Access Compliance Report

Public Rights-of-Way

| Intersection ID: 26585 | Main Street: ARBORHILL_RD | Cross Street: MANOR_HOUSE_DR | Location: SE |
| ADA ID: 31048978691B | Ramp Type: BlendTrans1 | Initial Pass/Fail: Fail | Overall Compliance: No |

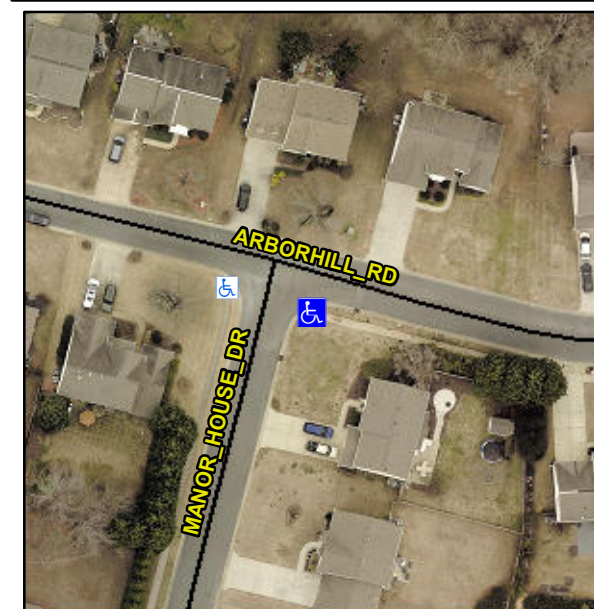
Not Found, R304.5.3

| Compliance | Description | Data | Compliance | Description | Data |
|------------|-----------------------|-------|------------|-----------------------------|------|
| Yes | Ramp Width (in) | 48.0 | No | BlendTrans XSlope (%) | 2.8 |
| | | | No | Curb Slope (%) | 16.6 |

Remove & Replace Curb Ramp With Two New Directional Ramps or Equivalent.
